O.6.3 Regional Agency Comments

RE: RCFD comments regarding the Draft EIR/EIS for the SR 91 Corridor Improvement Project

Notice of Public Hearing and Notice of Availability of the
Draft Environmental Impact Report / Environmental Impact Statement
for the State Route 91 (SR-91) Corridor Improvement Project

SR-91 CORRIDOR IMPROVEMENT PROJECT:
View Showing Project Boundaries and the Lower Feeder Pipeline

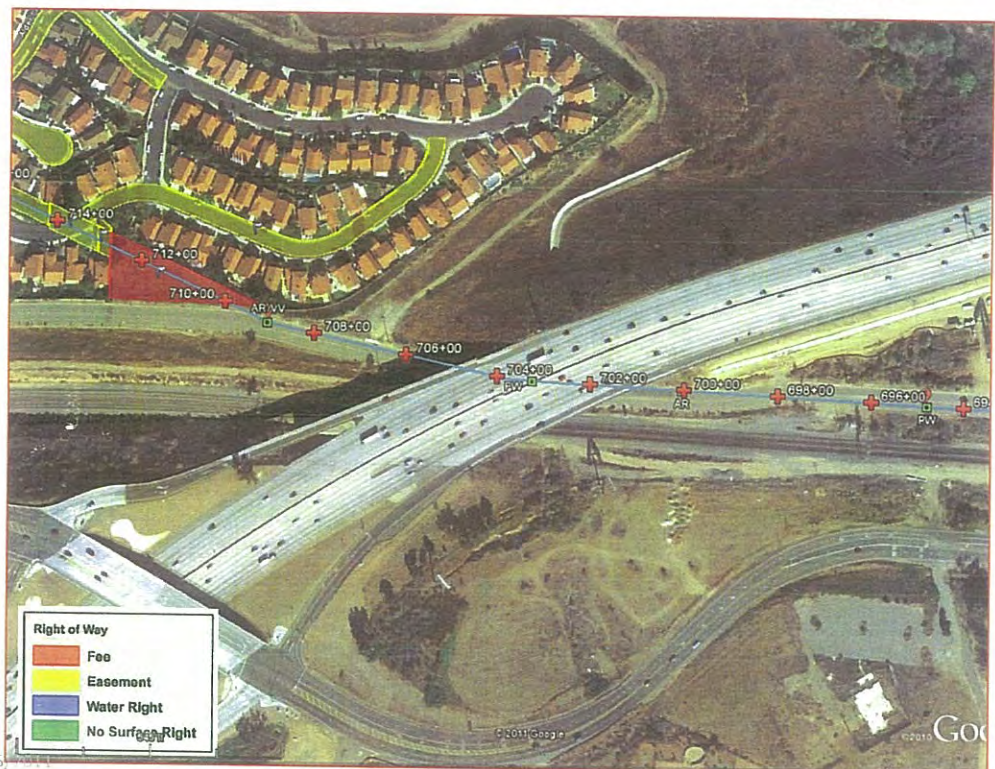
We have reviewed the Project description and have determined that the Lower Feeder pipeline, owned and operated by Metropolitan, is within the Project area. More specifically, the Lower Feeder pipeline intersects the Project's boundaries at two locations (see enclosed maps). The first location is at the South Weir Canyon Road intersection with SR-91 and is a 109-inch-inside-diameter welded steel pipeline. The second location is just south of the El Cerrito Road intersection with the I-15 and is a 108-inch-inside-diameter precast concrete pipeline.

In order to avoid potential conflicts with Metropolitan's facilities and rights-of-way, we require that any design plans for any activity in the area of Metropolitan's pipelines or facilities be submitted for our review and written approval. Approval of the Project should be contingent upon Metropolitan's approval of design plans for portions of the Project that could impact our facilities.

During the design-build phase of the project, it will be necessary to coordinate with and obtain clearance letters from Metropolitan. The Project Construction Manager, RCTC, and/or their designated representatives will contact Metropolitan as requested and provide appropriate project information and final design plans of the two locations where the Lower Feeder Pipeline crosses SR-91 and I-15.
